North Little Rock Planning Commission
March 11, 2025 - Agenda / Public Hearing 4:00 PM
City Council Chambers – 300 Main Street, NLR, AR 72114

**North Little Rock Planning Commission
Minute Summary
February 11, 2025**

COCK OF THE WALK LOT 2 SITE PLAN OF SUBDIVISION NORTH LITTLE ROCK, PULASKI COUNTY, ARKANSAS

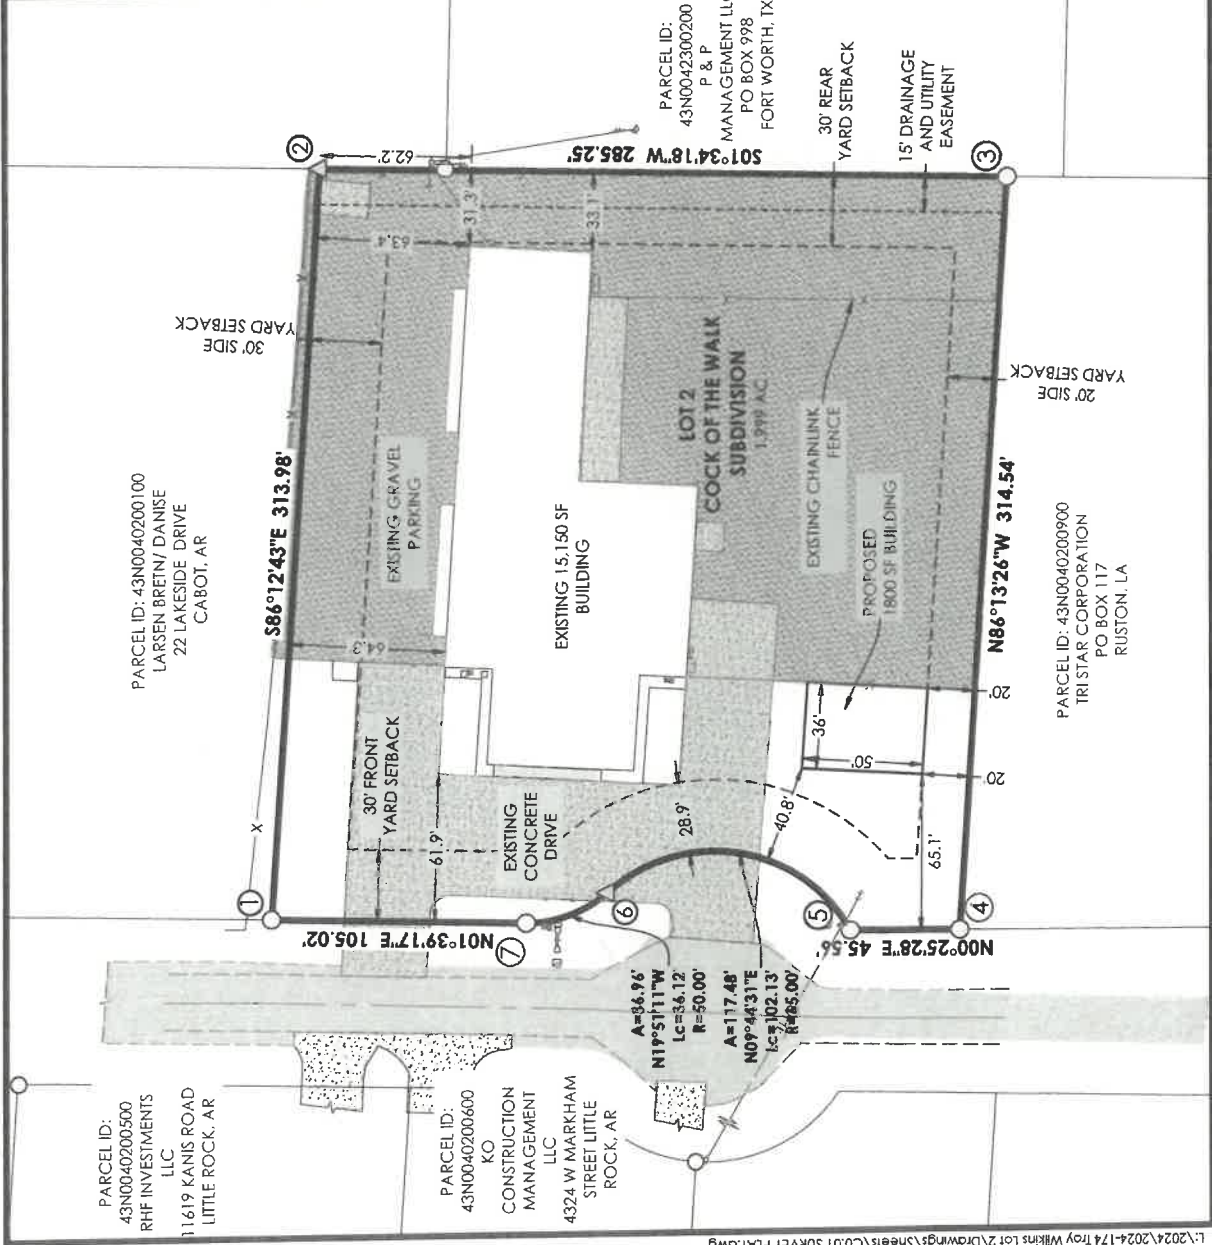
- a. A signed and recorded plat must be on file with the Planning Department.
 - b. If applicable, prior to construction, Owner's Engineer shall submit stormwater design report for review and approval by the City Engineer. Stormwater plans and detention calculations are to be approved by City Engineer and a written approval provided to Planning Department. Drainage submittal shall include, as a minimum, the following:

- i. Proposed pipe material specifications.
 - ii. Proposed trench and bedding details, materials and specifications.
 - c. If applicable, provide CNLR Grading Permit application to City Engineer with grading plans.

- d. Provide CNLR Stormwater Permit application to City Engineer with half size erosion control plan showing silt fence, storm inlet protection, and drainage details.

- e. Provide CNLR driveway/curb cut permit application to City Engineer or copy of ARDOT driveway permit if State Highway.
 - f. If applicable, provide copy of Arkansas Department of Environmental Quality (ADEQ) Stormwater Permit to City Engineer.

3. Meet the requirements of the City Engineer, including:
 - a. Prior to any excavation/street cuts within street ROW, provide CNLR Excavation Permit to City Engineer and Barricade Plan Permit to NLR Traffic Services.

- b. Contractor shall notify City Engineer at least 1 day prior to the construction of all stormwater pipes and inlet structures within City ROW.
 - c. At the end of construction, Owner/Developer shall have a Professional Engineer, licensed in the State of Arkansas, certify that all street and stormwater improvements in conjunction with this subdivision and/or the proposed development have been inspected and constructed in accordance with the approved plans and meet all City of North Little Rocks Standard Specifications.

- g. All driveways are to be concrete within the ROW.
- h. Provide ½ street improvements (street, drainage, curb and gutter, sidewalk, street lights) or a performance bond.

- 5. Meet the requirements of the Master Street Plan, including:
 - a. Provide 5' sidewalks and ramps with a minimum of 5' green space between sidewalks and curb to ADA standards and City standards.

- b. Any new site development must comply with the City's minimal landscape and buffer ordinance requirements.
 - c. Provide street trees at a minimum rate 1 tree per 30 linear feet of property line adjacent to the street right-of-way.

- ii. Provide a minimum of 10 trees adjacent to the E 10th St right-of way.
 - d. Landscape plans to be revised prior to the March 2025 Planning Commission Hearing.

10. Meet the requirements of NLR Wastewater, including:
- a. Please add 15' exclusive sanitary sewer easement centered over the existing sanitary sewer mains within the property boundary.

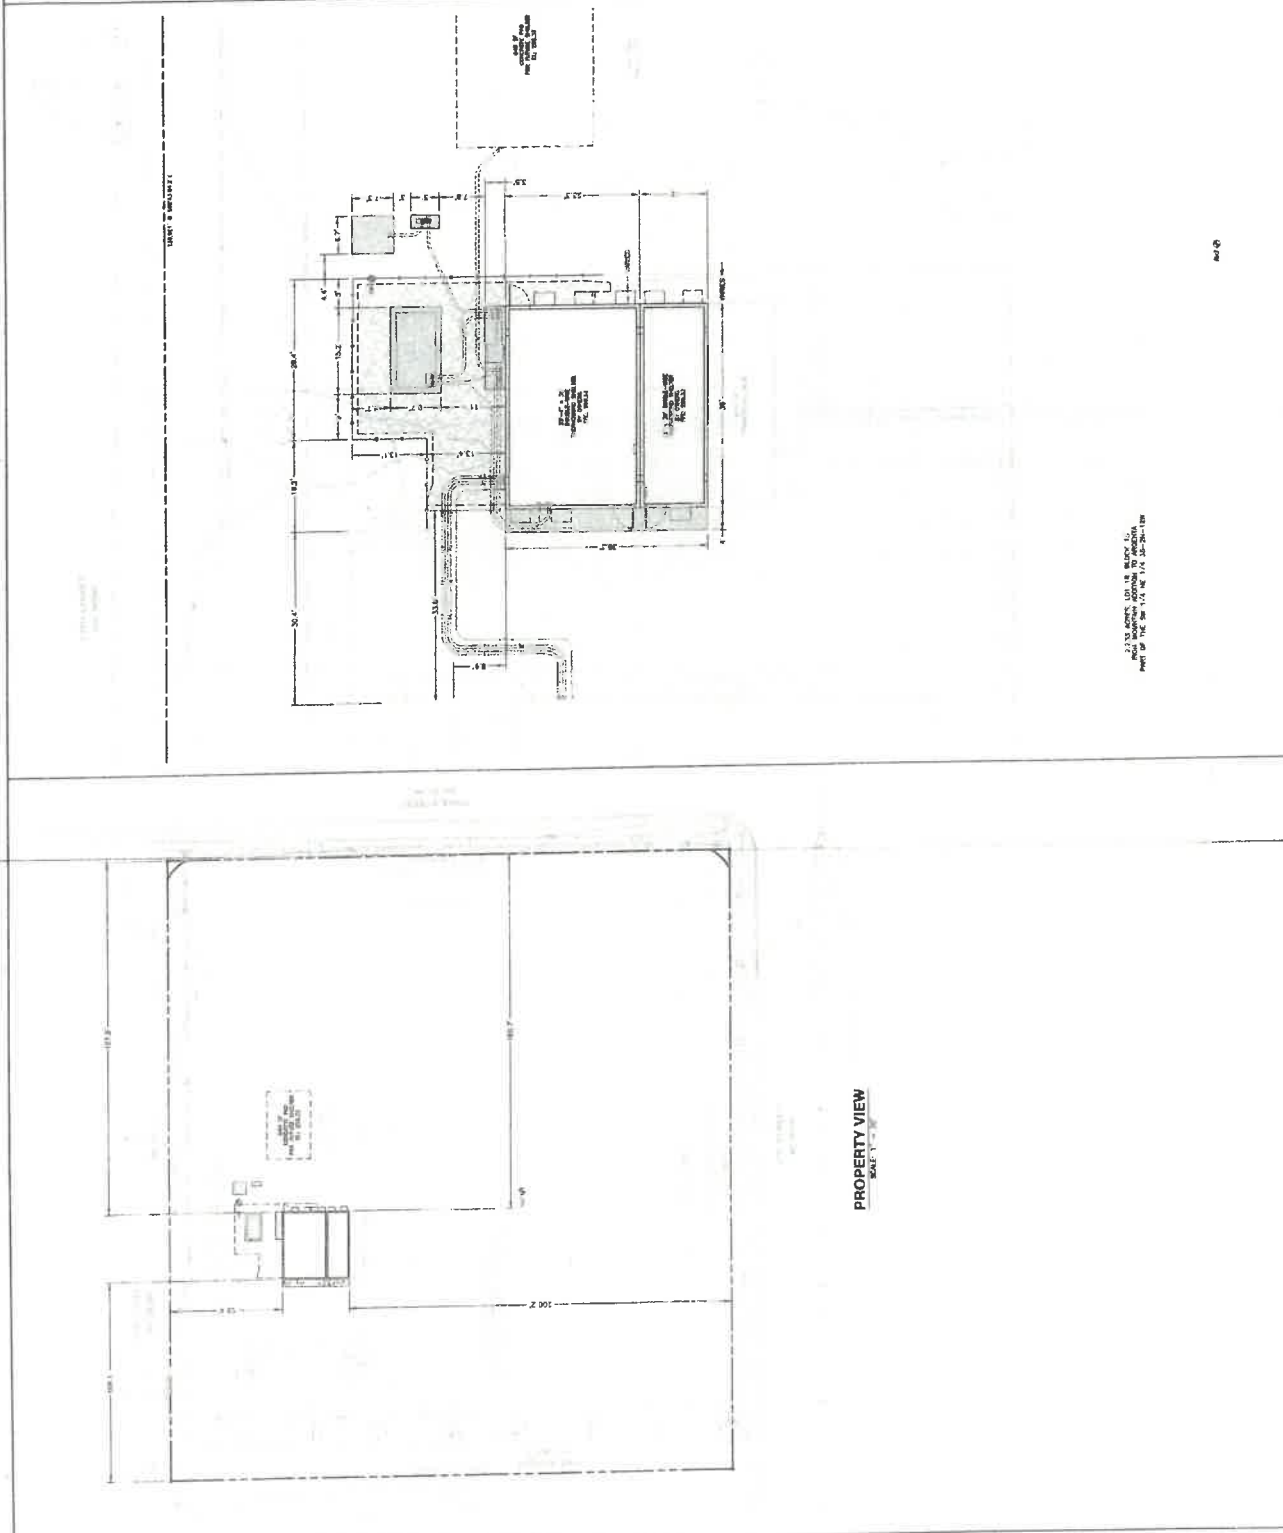
1. Provide a copy of the recorded final plat for the lot as noted on the site plan "the lots have been combined into a single lot".
2. Engineering requirements on detention:

- a. Provide on-site storm water detention as well as clear calculations showing that detention volume is sufficient, or demonstrate to City Engineer that on-site detention is not required (based on proposed development) by providing detention calculations showing pre and post site runoff comparisons.

3. Permit requirements/approvals submitted before a building permit will be issued:
 - a. A signed and recorded plat must be on file with the Planning Department.

- b. Prior to construction, Owner's Engineer shall submit stormwater design report for review and approval by the City Engineer. Stormwater plans and detention calculations are to be approved by City Engineer and a written approval provided to Planning Department. Drainage submittal shall include, as a minimum, the following:

4. Meet the requirements of the City Engineer, including:
 - a. Prior to any excavation/street cuts within street ROW, provide CNLR Excavation Permit to City Engineer and Barricade Plan Permit to NLR Traffic Services.

- b. Repair or replace existing sidewalk and curb to City Engineer's standards.
